Product Change Notification: E-21-005720

General Product Description:
AMPMODU MTE HEADER ASSEMBLIES

Description of Changes
ADDENDUM TO PCN E-20-000624 (ATTACHED). ONE OF THE CHANGES NOTED IN PCN E-20-000624 IS NOT BEING IMPLEMENTED DUE TO FINANCIAL IMPLICATIONS. THE TOOLING CHANGE SHOWN IN THE ATTACHED MTE SHROUDED HEADER TOOLING CHANGE FILE IS BEING MADE TO BE AT THE MOLDER'S DISCRETION. SOME PARTS MAY HAVE THIS RECESSED AREA, SOME MIGHT NOT. THERE IS NO PERFORMANCE DIFFERENCE BETWEEN THE PARTS WITH THE RECESSION AND THE PARTS WITHOUT THE RECESSION.
Other attachments:
[MTE Shrouded header tooling change](#)
[PCN E-20-000624](#)

Product Change Notification: E-20-000624

MTE SHROUDED HEADER HOUSING TOOLING CHANGE

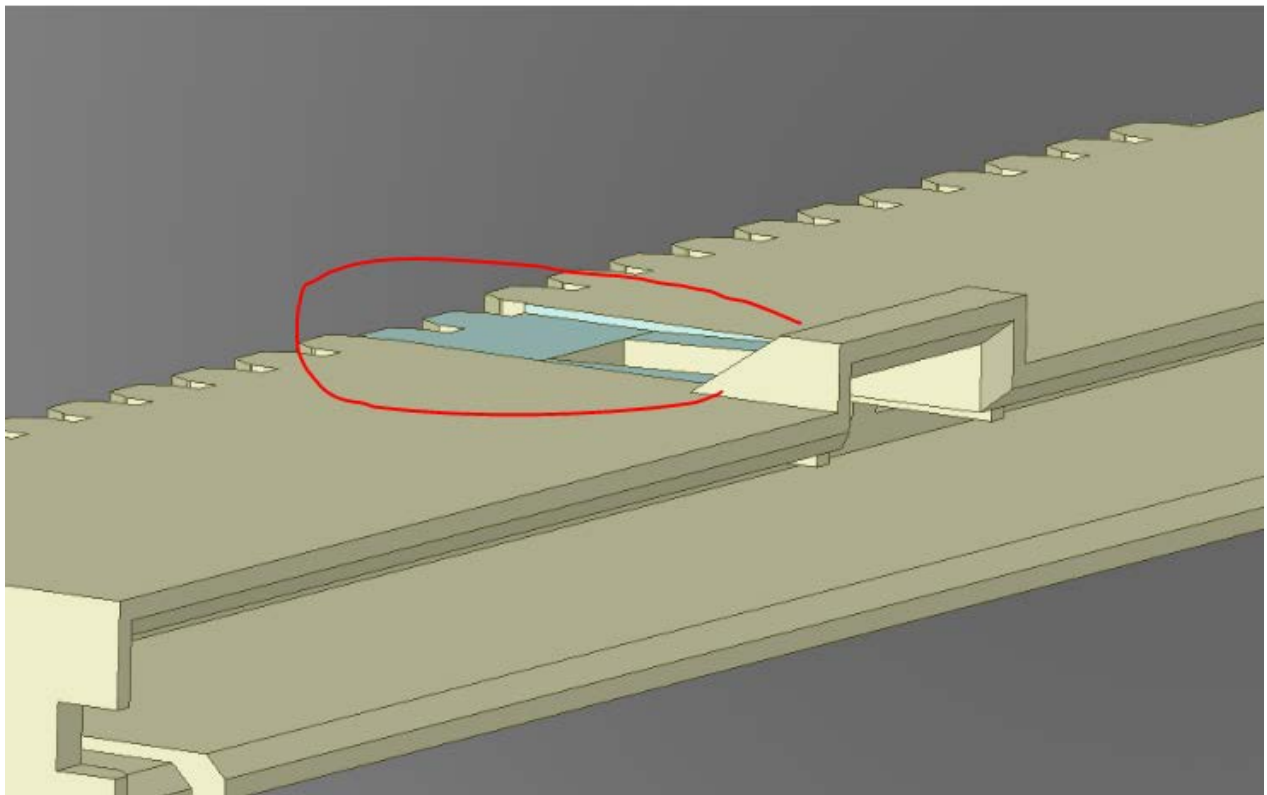
CURRENT HOUSING BEFORE CHANGE

HOUSING AFTER CHANGE
